# SCUBAPRO<sup>®</sup>

## *Technical Service Reference & Repair Guide*

**Mark 15 Upgrade**  
*Assembly*

SCUBAPRO® Mark 15 First Stage  
**Piston & HP Seat Components**

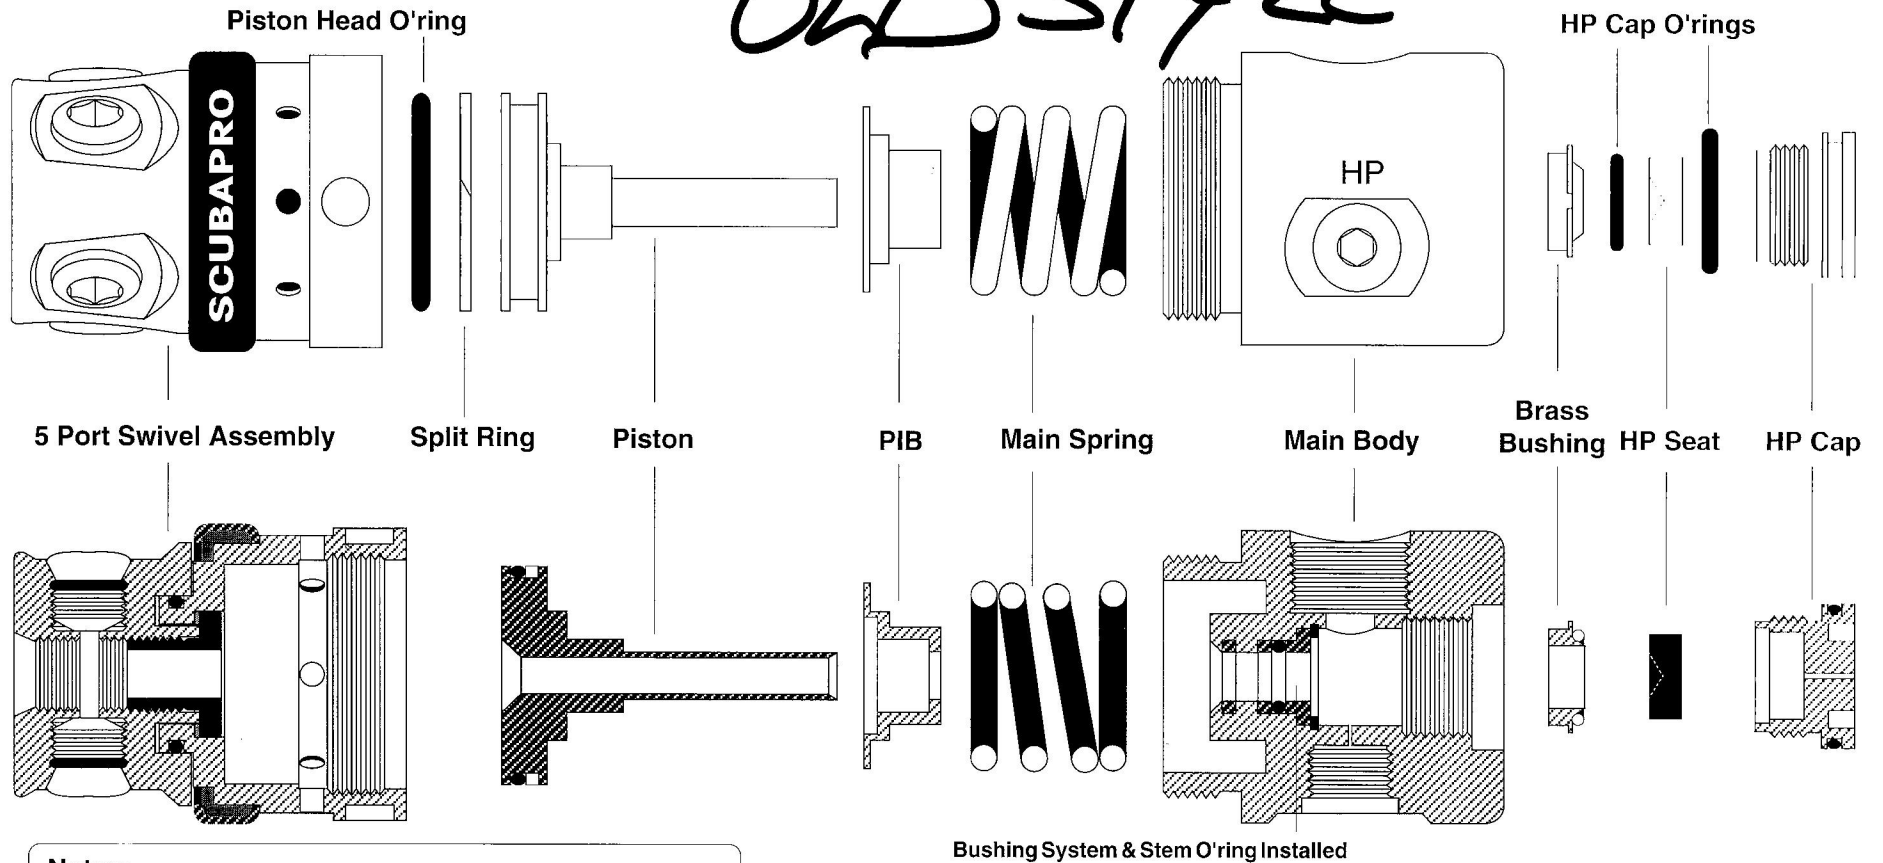
The components to the right are the original HP seat components used in the Mark 15 first stage. These were downgraded to 3000 psi. Replace with the components shown in the main illustration at the service interval.

The illustration above shows the piston and high pressure seat components. The swivel o'ring, piston head o'ring, piston stem o'ring, HP seat, and rear bushing system should be replaced during annual service. The PIB should be packed to the piston with silicone grease to prevent water exchange in this area. Lubricate all dynamic o'rings using the proper procedure. Be sure to stay up-to-date on the latest engineering information regarding HP seats available as replacement parts.
